MCB Issues List APR1400, FSAR SECTION 6.5.2

Issue #1(6-18.1)

Figure 1 Variation of the TSP concentration in the IRWST after LOCA

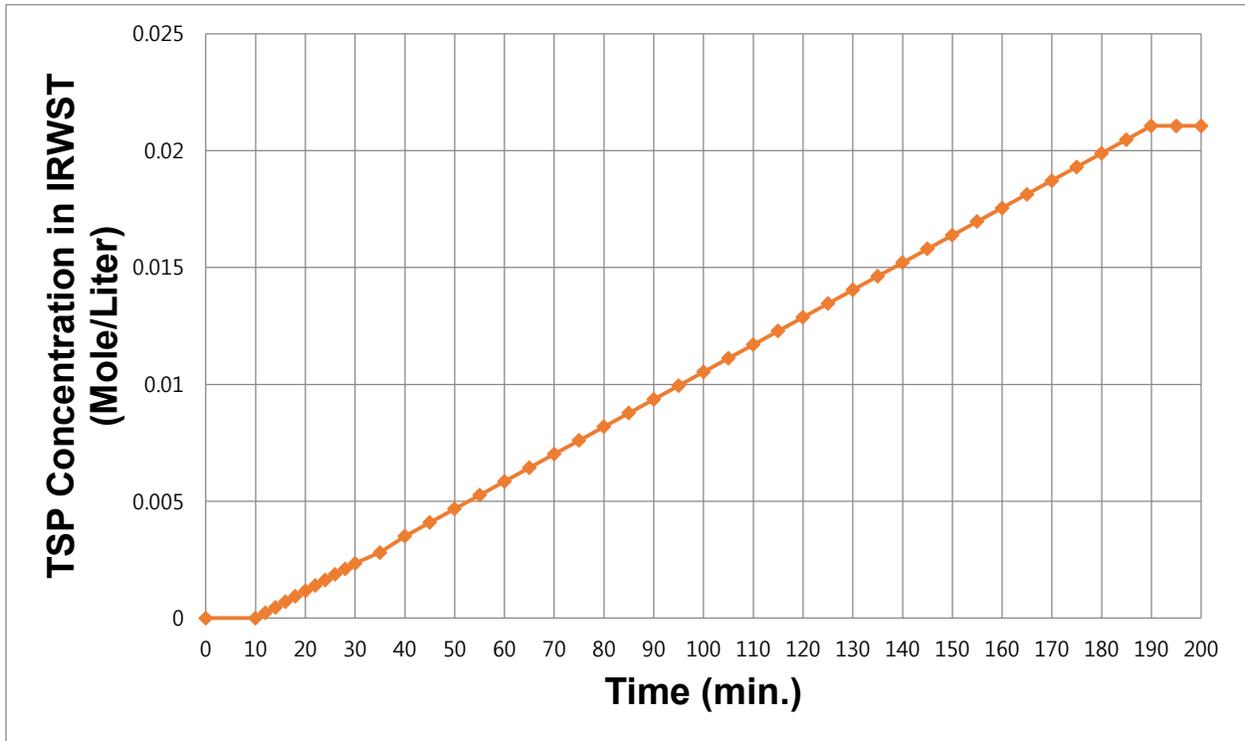
Although the timing of the pH rising above 7 appears reasonable and in agreement with Standard Review Plan (SRP) Section 6.5.2 recommendations, the staff will need to corroborate this timing with the applicant's calculation. To do so, the staff requires additional information regarding the applicant's calculations and modeling assumptions which support the determination of how pH changes with time.

Explain in more detail how the evolution of pH was modeled and supply specific details of the pH calculation (e.g., actual calculations, assumptions, pH/time graphs). Please include technical justification for all of the assumptions and details of the specific methodology being used. If a technical report which contains this information already exists, the applicant may choose to provide it to the staff in response to this issue.

The TSP concentration in the IRWST based on the equations (23) through (25) is increased linearly as shown in Figure 1, and the pH is determined according to Section 4.

Figure 2 Time Dependent pH Calculation

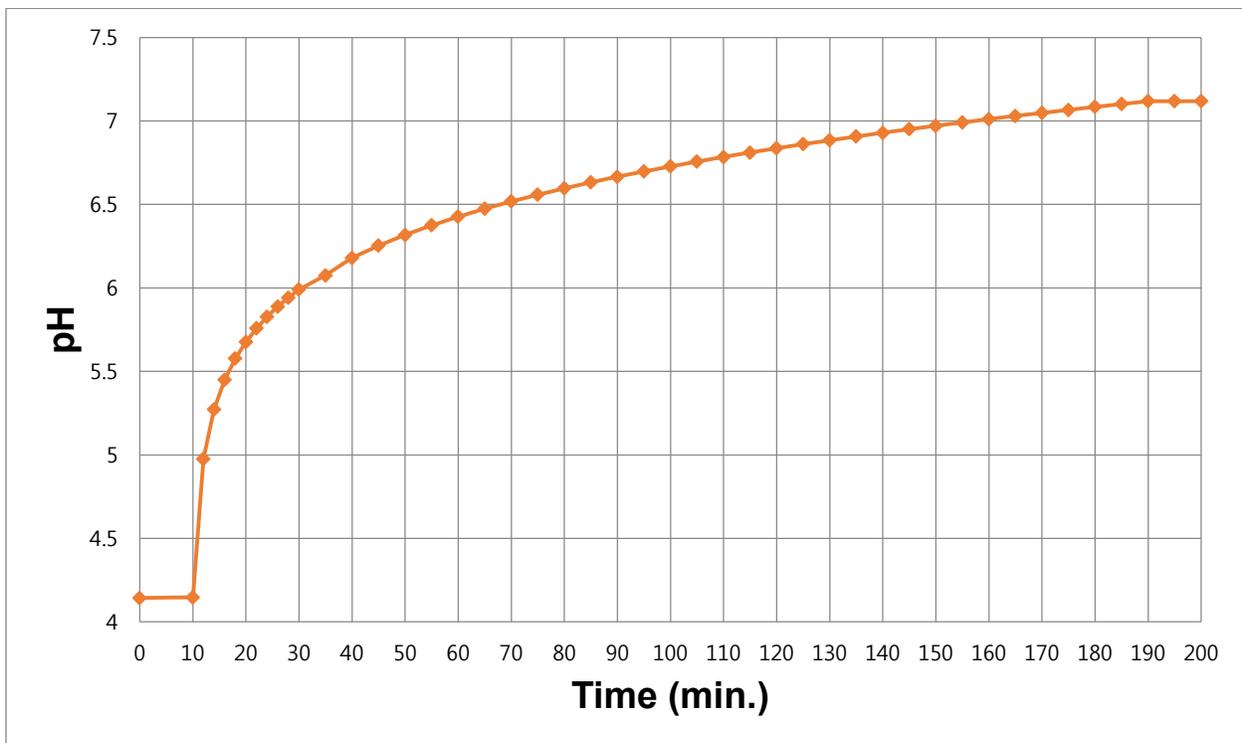
In APR1400 FSAR Section 6.5.2.3.2, the applicant describes the Containment Spray pH control. The applicant states that the calculations show that the pH in the in-containment refueling storage tank (IRWST) will reach a pH of 7.0 by 157 minutes after a DBA. However, there is no information on the initial pH of the IRWST.

Provide additional information that identifies the initial pH of the IRWST and explains the initial scenario before the DBA.

The calculation results of the minimum pH value as a function of time are shown in Figure 2. The pH reaches 7 at 157 minutes after the LOCA.
